# **AQUIND INTERCONNECTOR**

Statement of Common Ground Between  
AQUIND Limited and Highways England  
FINAL

Document Ref: 7.5.10  
PINS Ref.: EN020022

**DATE: 25 FEBRUARY 2021**

Figure 1: Junctions in the Study Area  
(Source: SRTM DAR Appendix B)

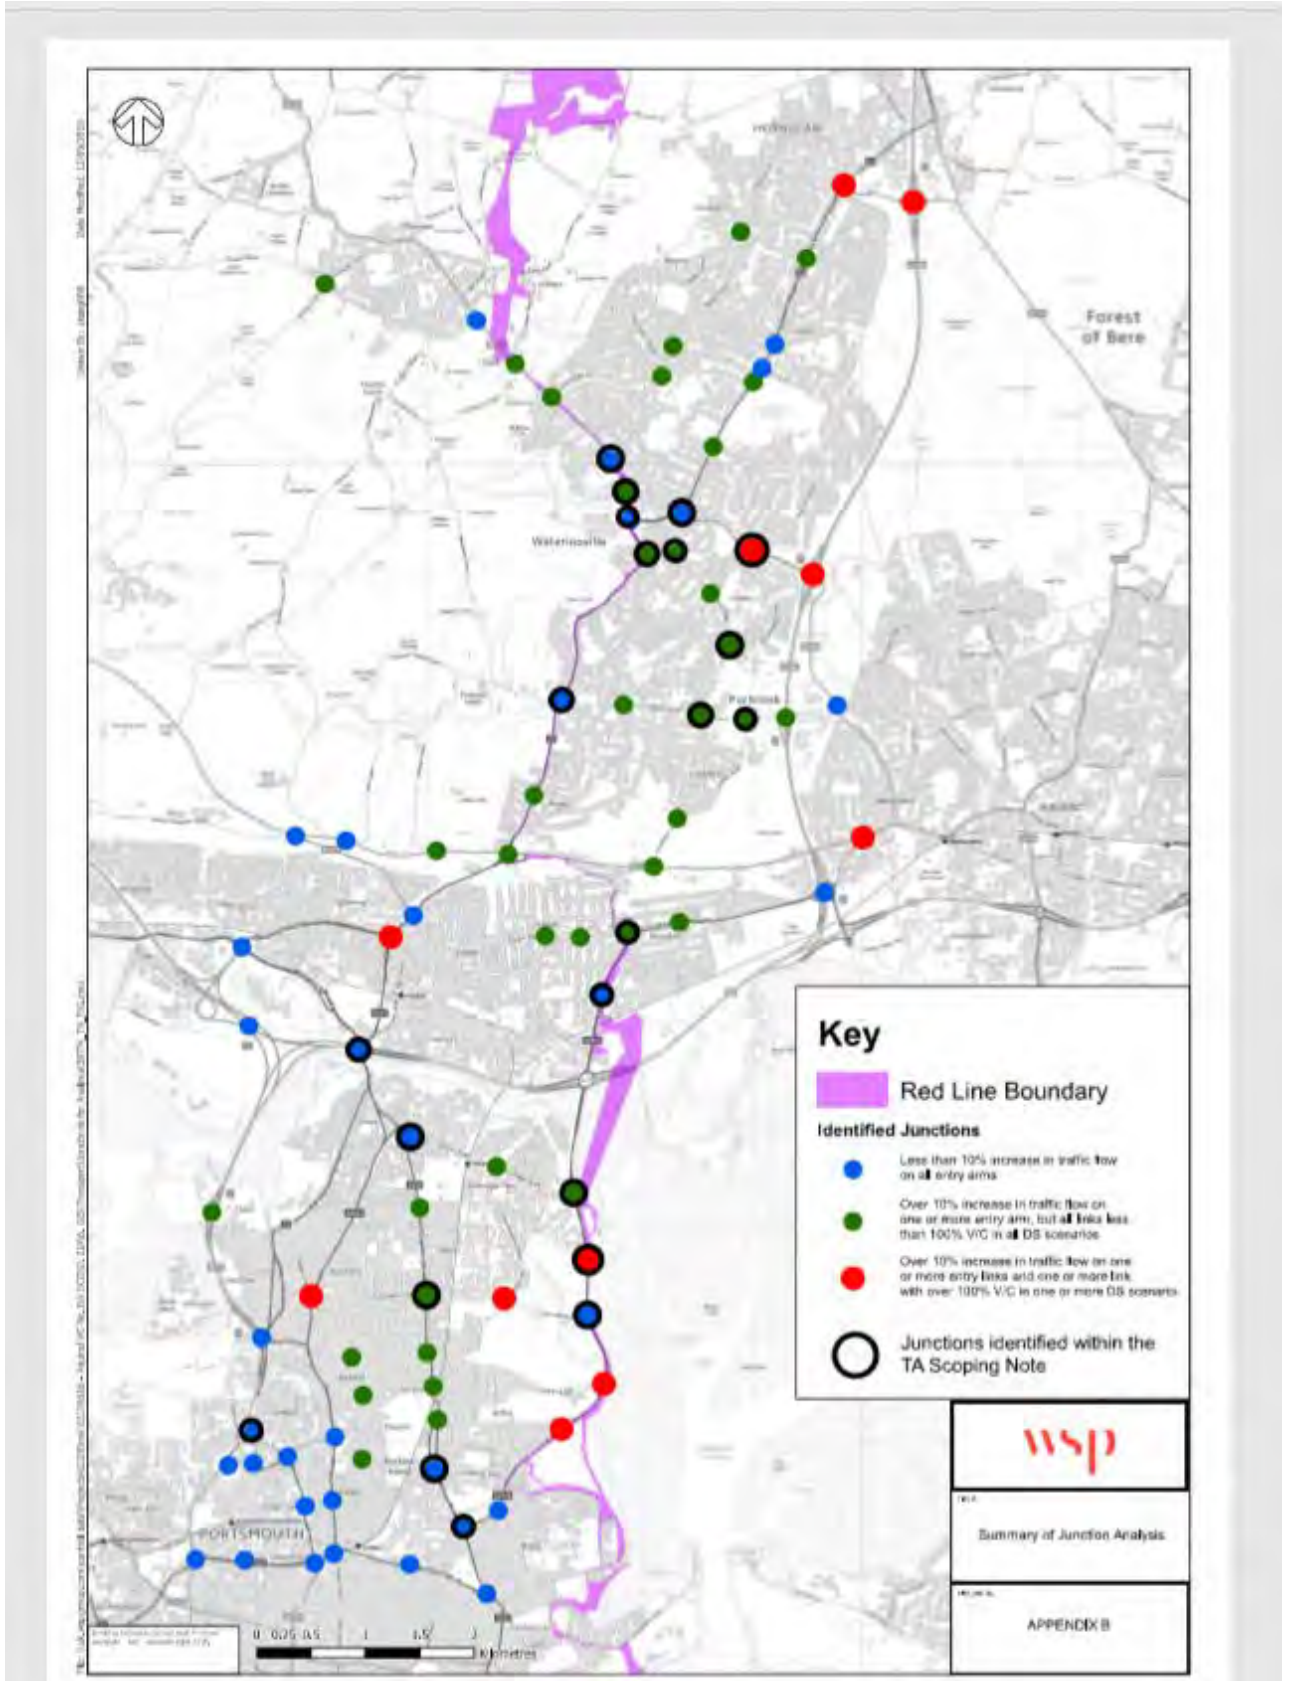
- 1.10. Examination of this Figure shows what looks like a works site access located off the A2030 immediately to the north of its junction with the A27, which might have the potential to give rise to an impact at the A27/ A2030 junction itself.

- 2.8. These junctions are identified by the use of red circles on Figure 1 of this TN.
- 2.9. The SRTM DAR gives details of key traffic flow increases, some of which are significant (the highest being 197 additional vehicles in the peak hour).

Figure 1: Junctions in the Study Area  
(Source: SRTM DAR Appendix B)

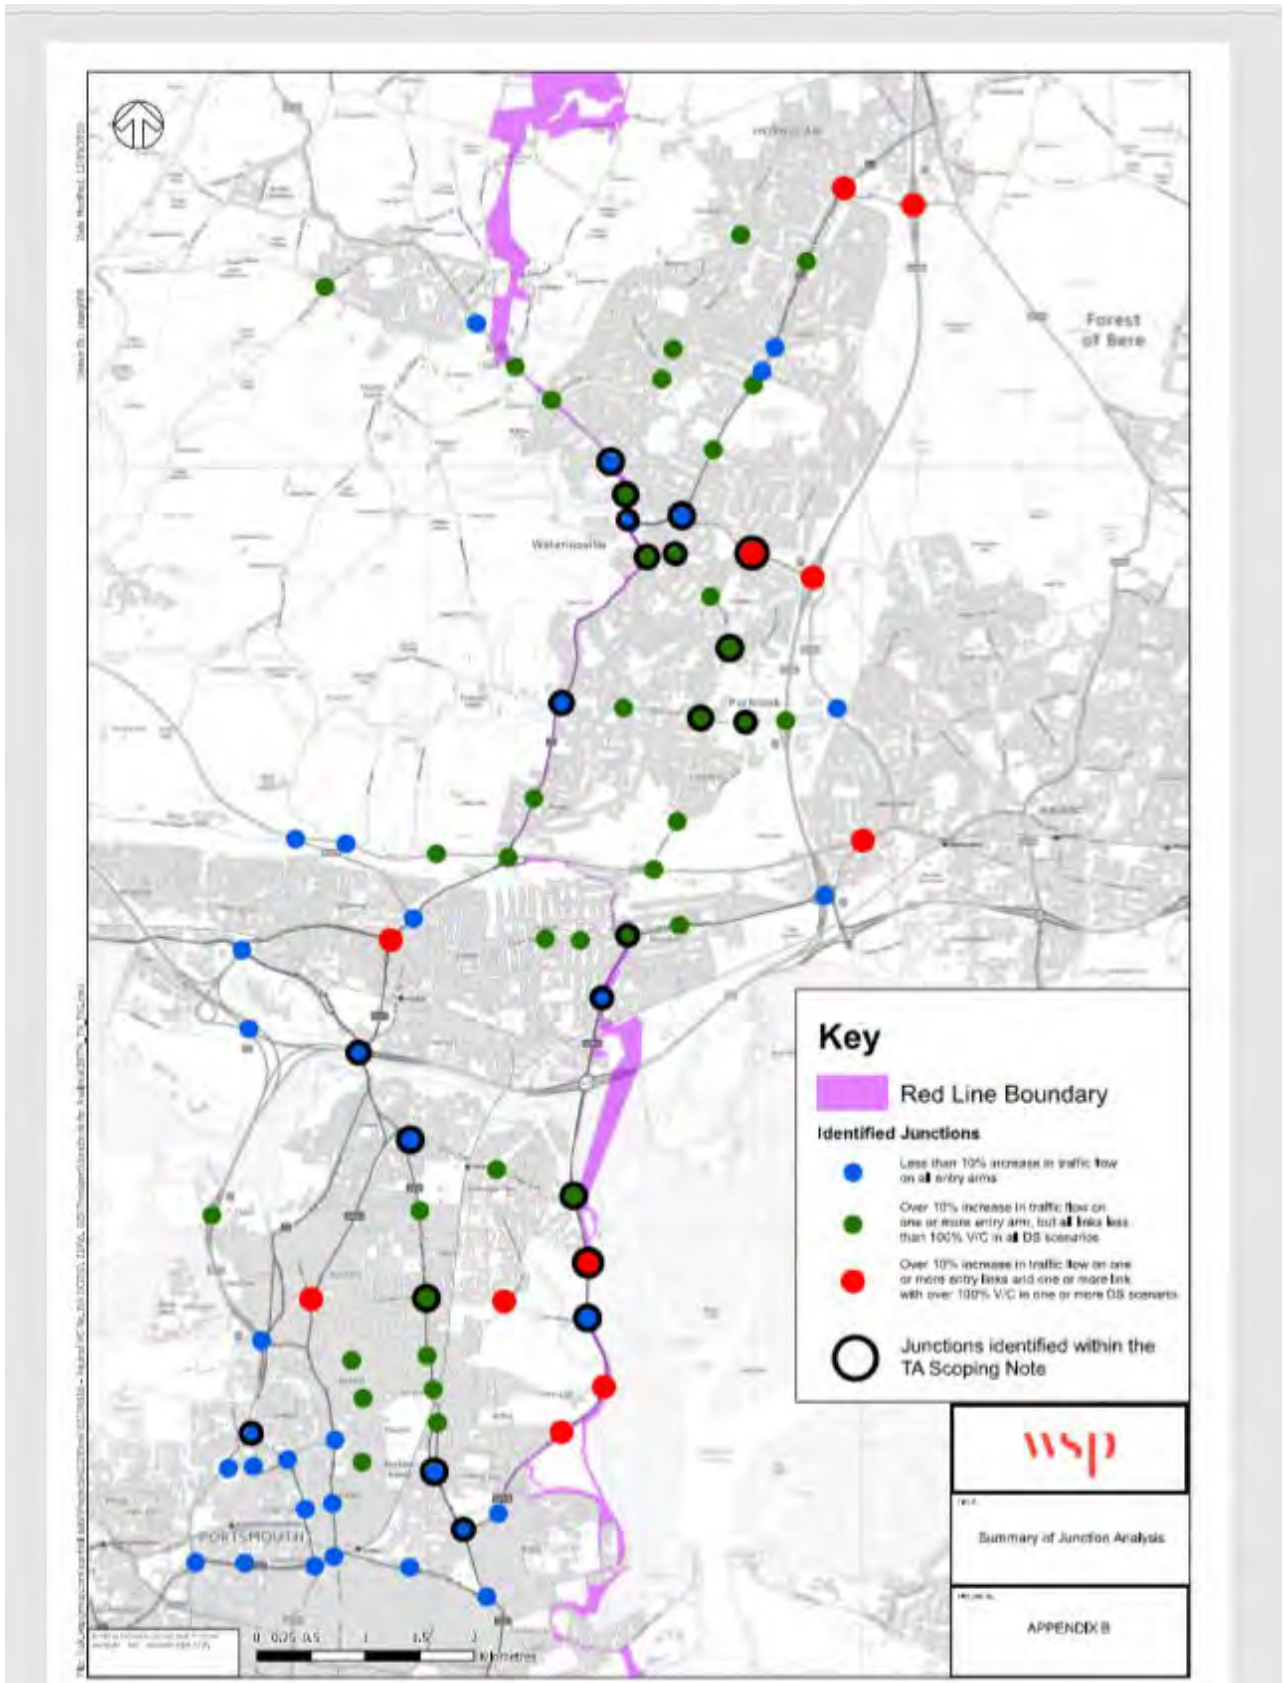
- 1.11. With the exception of the A27/ A2030 junction (which AECOM has previously recommended should be included), these locations were illustrated on the figure at Appendix B of the SRTM DAR, a copy of which is reproduced at Figure 1 on the following page.

- 1.12. The extent to which the ES and TA quantify the impact of the proposals at these locations is considered further in this TN02. The recommendations in this TN are identified by the use of **bold underlined text**.

# **Appendix 2 – Swept Path Analysis (Farlington Playing Fields)**

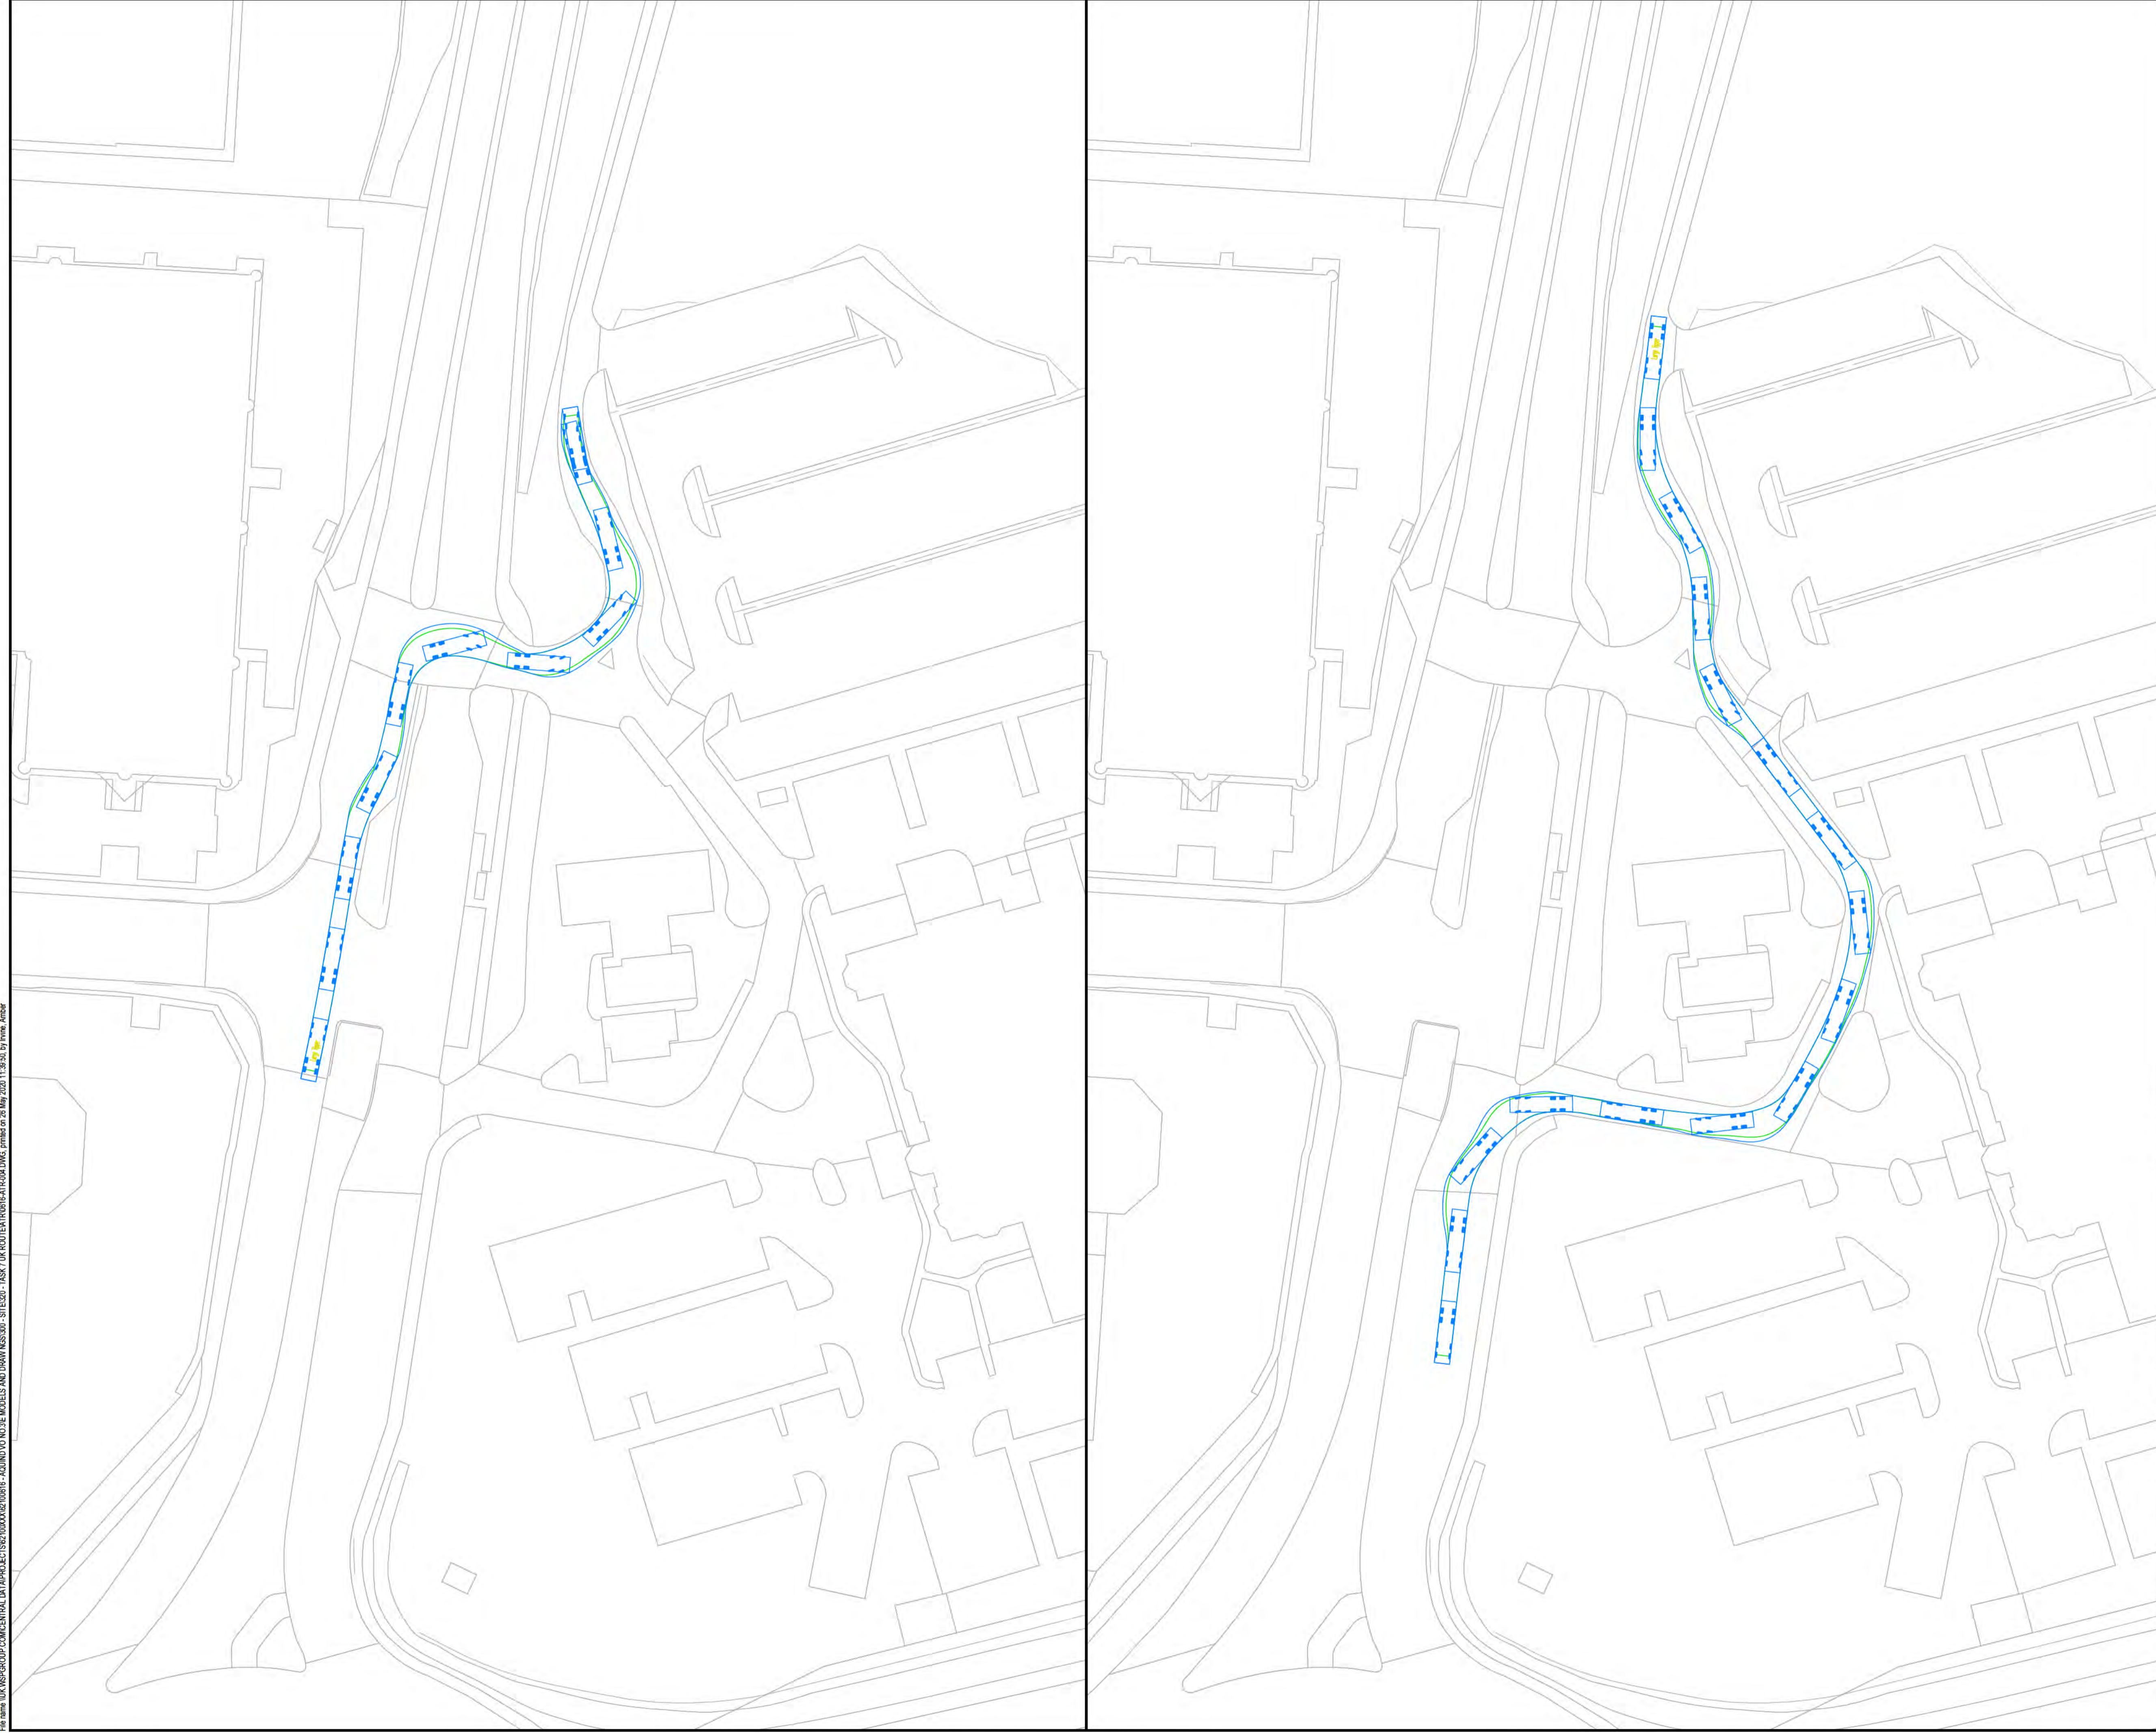
- The adequacy of the current layout of this junction or whether any modifications are required to accommodate the vehicles bringing the HDD drilling equipment and taking away spoil – this should be confirmed through the provision of HGV swept path plots;

- 7.2.1.1. Swept path analysis has been undertaken of the entrance and egress routes into Farlington Playing Fields as illustrated in WSP Drawing 0616-ATR-002, which is included within Appendix 2. For the purposes of this assessment, a custom cable drum delivery vehicle referred to as 'Hammar 155' was utilised as this will be largest vehicle that is required to enter / exit Farlington Playing Fields. This consists of an articulated HGV with a tractor unit and low loader trailer which is 14.65m long and 3.95m wide. A clearance of 700mm has been incorporated into the vehicle dimensions to represent the overhang of the cable drum.

7.2.1.3. As shown in WSP Drawing 0616-ATR-002, the cable drum delivery vehicle can access the site by straddling the offside and nearside lanes on the northbound carriageway of the A2030 Eastern Road. At the entrance to the Farlington Playing Fields Car Park, the cable drum delivery vehicle would over-run the existing central island and the grass verge on the inside corner (nearside of vehicle). On the outside of the corner, there would be some vehicle overhang, but the vehicle track remains within the extent of the carriageway.
